CITY OF MERCED
Planning & Permitting Division

STAFF REPORT: #19-07

SUBJECT: **Vesting Tentative Subdivision Map #1310**, initiated by Benchmark Engineering, applicant for Baxter Ranches, LLC, property owner. This application involves the subdivision of approximately 32.7 acres of land into 188 lots (“Bellevue Ranch West, Village 18-A”) and approximately 11.4 acres into 61 single-family lots (“Bellevue Ranch West, Village 17-C”). This property is generally located on the west side of M Street, north of Arrow Wood Drive, within Planned Development (P-D) #42 and has a Low-Medium Density (LMD) and Low Density (LD) Residential General Plan Designation. *PUBLIC HEARING*

COVER SHEET
VESTING TENTATIVE SUBDIVISION MAP
BELLEVUE RANCH WEST
VILLAGE 17 & 18
MERCED, CALIFORNIA

LOT DIMENSION PLAN
 BELLEVUE RANCH WEST
 VILLAGE 17 & 18
 MERCED, CALIFORNIA

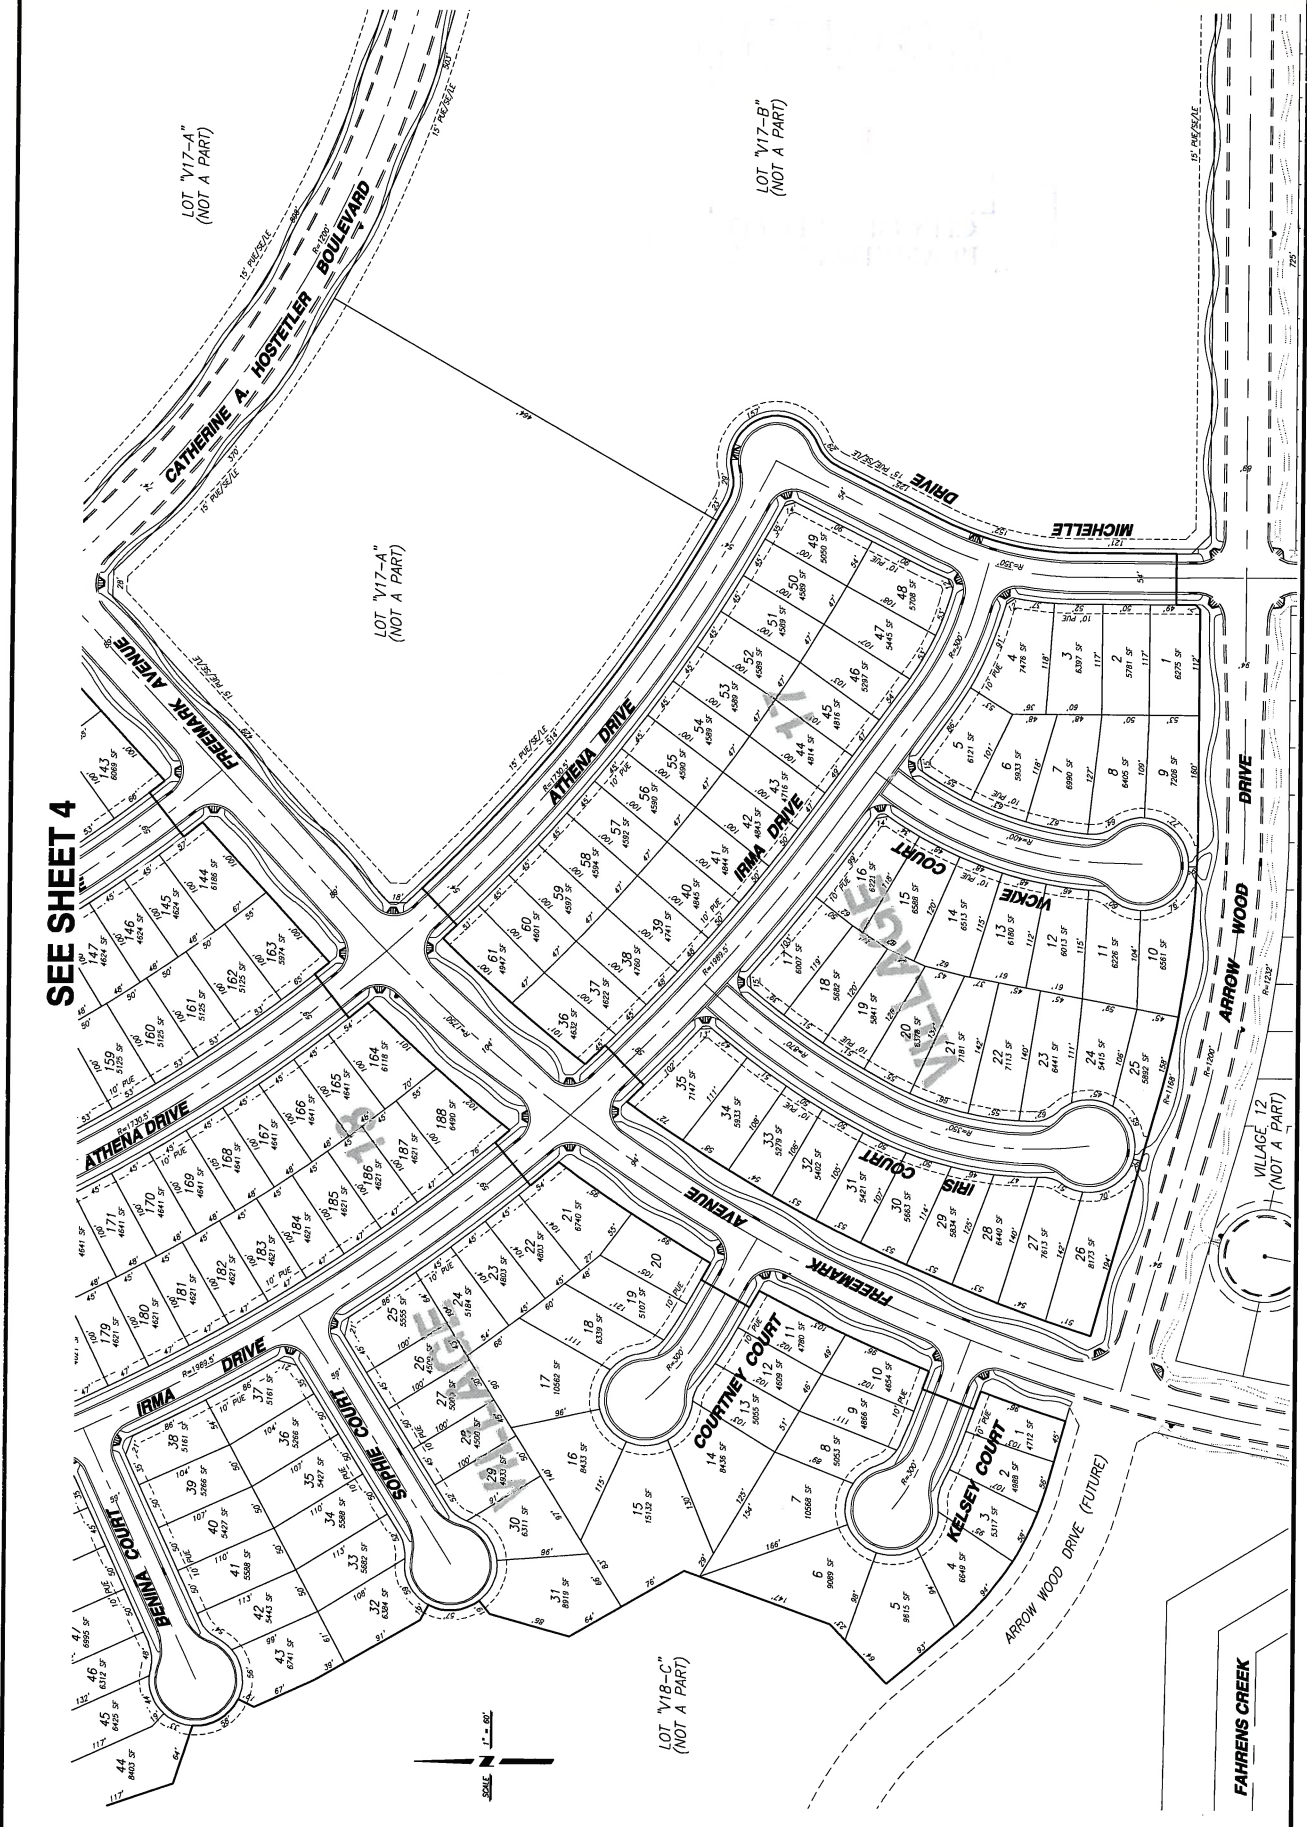
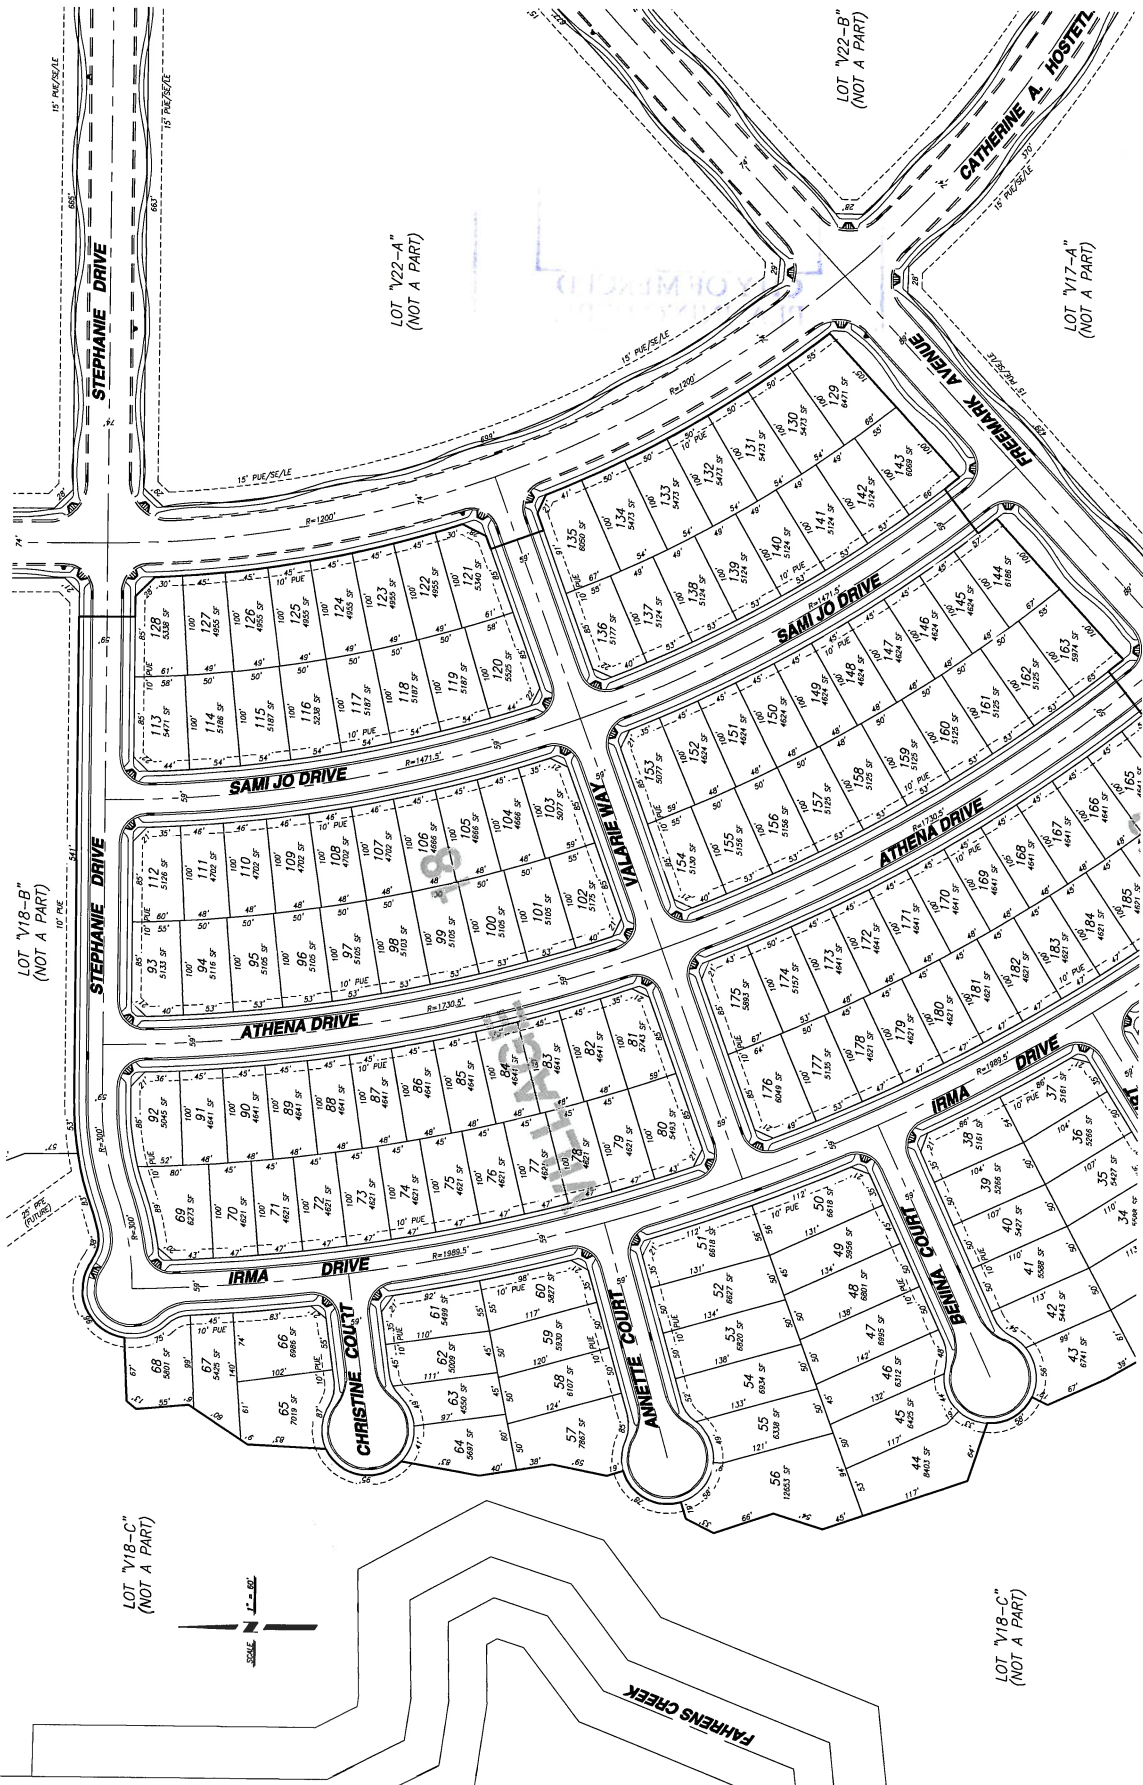
- *1) The proposed project shall be constructed/designed as shown on Exhibit 1 (site plan) - Attachment B, except as modified by the conditions.
- *2) All conditions contained in Resolution #1175-Amended ("Standard Tentative Subdivision Map Conditions") shall apply.

- J) The proposed lots would range in size for Village 17C from 4,589 square feet to 8,173 square feet. For Village 18A, the lots range from 4,500 square feet to 15,132 square feet. This provides a wide range of lot sizes and development opportunities. All the lots have a minimum average depth of 100 feet and a minimum width of 45 feet. Per the BRMDP, standard single family lots shall be a minimum of 4,000 square feet. Therefore, this proposal is in compliance with this requirement.

Individual lots would be required to meet the setback requirements set forth in the BRMDP which requires a 20-foot setback from the public street right-of-way for all garages, but allows the setback for the living area to be reduced to 15 feet (refer to the diagram at Attachment E and Condition #13).
